Addendum #2 6/8/2020
Newton Place PENQUIS Grandview Ave., Bangor

Reference Architectural Bidding Documents dated April 16, 2020

2 Pages, including SK-A1.

SK-A1

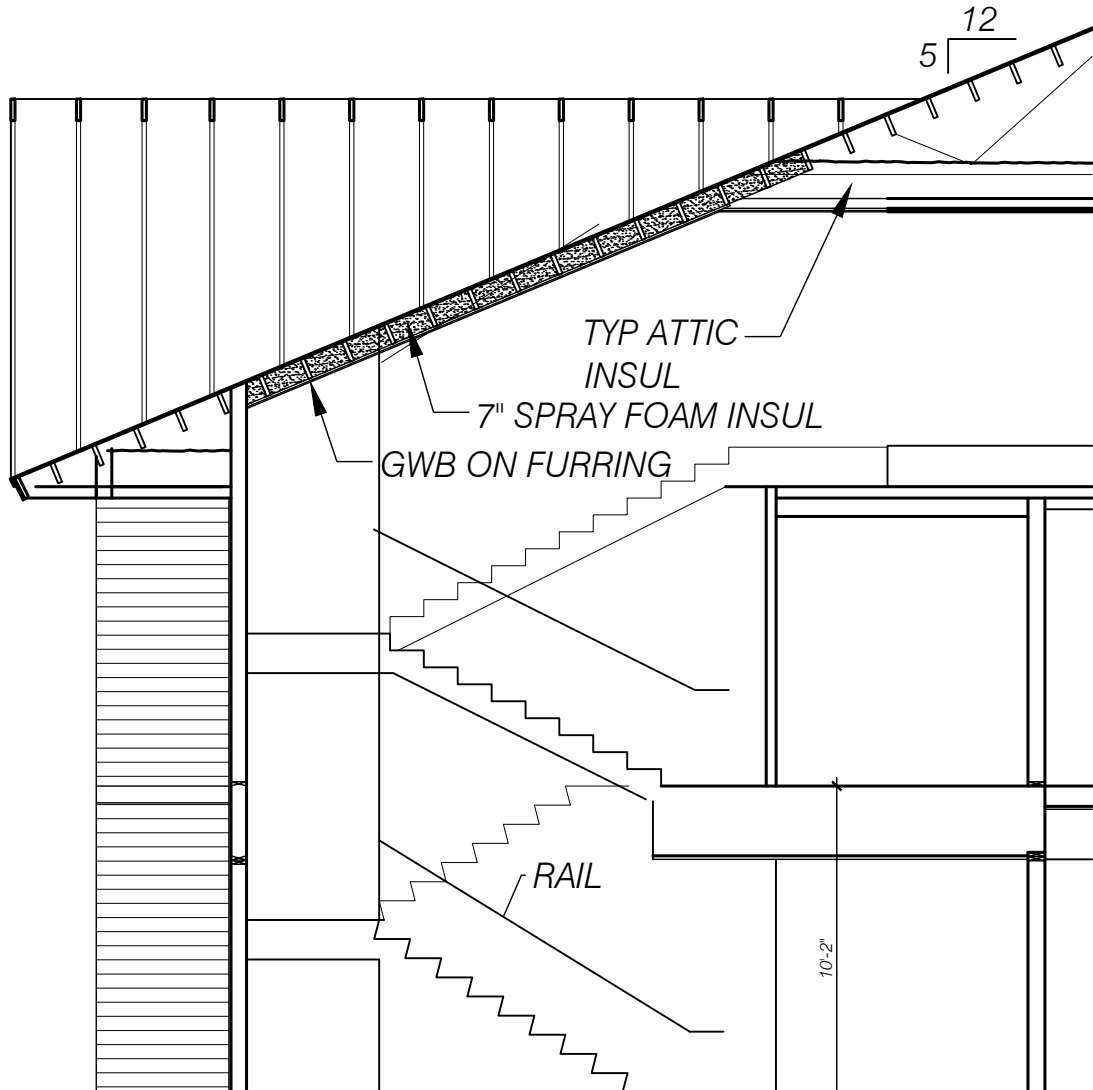
6" Glass fiber insulation for all floor/ceilings including the corridors except third floor ceiling. This is indicated on 1/A6 but not shown everywhere. Ignore the notes that indicate rock wool here. Otherwise all ceilings are to be included.
4. **Drawing A5.1**, Change: See attached SK-A1 for construction and insulation at stair ceiling.
5. **Drawing A6**, Detail 3, Clarification of cantilevered second floor insulation: 6" glass fiber in floor with 2" foil-faced iso-board under the assembly.
6. **Drawing A8**, Change: Any of the rated doors of style B may be primed wood as long as the rating is maintained. If they are steel as indicated, the panel affect can be created with add-on trim.
